SUNDRY NOTICES AND REPORTS ON WELLS

8. Well Name and No.
BISTI COAL 5 COM 2

Plug and Abandonment Procedure

BLM FLUID MINERALS
Geologic Report

Proposed Wellbore Diagram

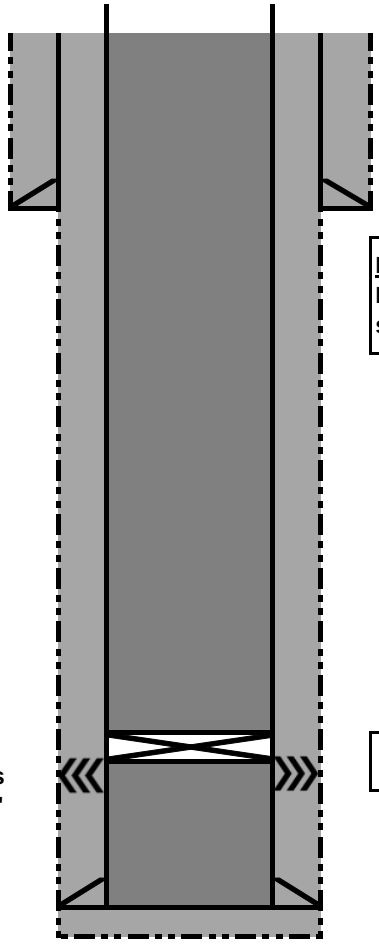
- The proposed plugging plan, if executed as presented, will adequately protect the freshwater sands in this well bore.

- Please ensure that the tops of the Pictured Cliffs and Fruitland formations as well as the entire Ojo Alamo aquifer, identified in this report, are isolated by proper placement of cement plugs. This will protect the freshwater sands in this well bore.
